Work Order ID 89019

Item ID: D407-667-105 Accept *N900040100* Setup Start *NS1*
 Revision ID: Stop *NS2*
 Item Name: Crosstube Fwd
 Start Date: 8/17/2012 Start Qty: 1.00 *1* Cust Item ID:
 Required Date: 8/24/2012 Req'd Qty: 1.00 *1* Customer:
 Reference: NCR 12-1695

DART SERVICE INSTRUCTION

TO AMEND INSTALLATION INSTRUCTIONS IIN-D206-667 REV. D AND EARLIER AND
INSTRUCTIONS FOR CONTINUED AIRWORTHINESS ICA-D206-667 REV. 3 AND EARLIER

FIGURE 1 - GROUNDING STRAP INSTALLATION
(VIEW LOOKING FWD)

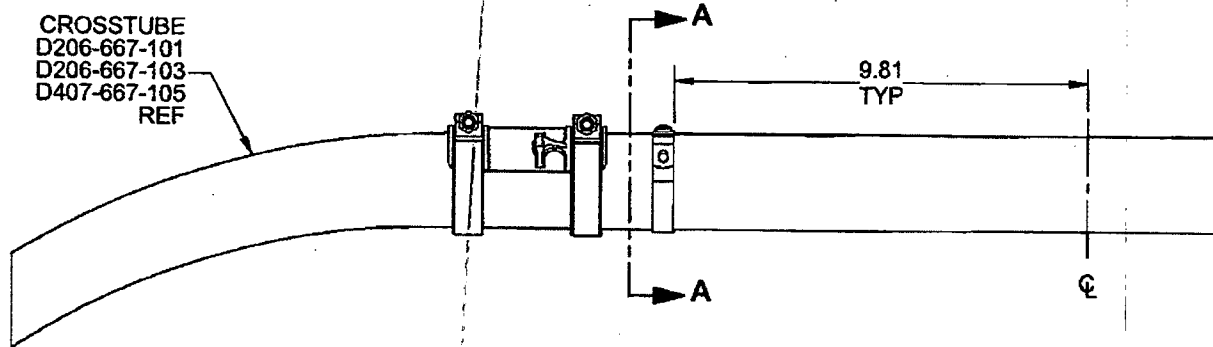
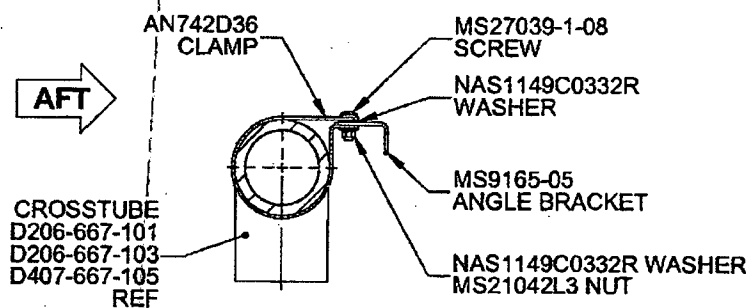
- 1) If installed, follow Section 32.1 of ICA-D206-667 for removal of the forward crosstube from the helicopter.
- 2) Locate AN742D36 Clamp as shown in Figure 1 of this service instruction and mark location of clamp on the crosstube.

- 4) Install AN742D36 Clamp complete with MS9165-05 per Section A-A of Figure 1 of this service instruction.
- 5) Touch up paint as required per Item 5.3.3 of ICA-D206-667.

SECTION A-A
(SUPPORT, CLAMP, CUSHION NOT SHOWN FOR CLARITY)
TYP, 2 PL PER CROSSTUBE
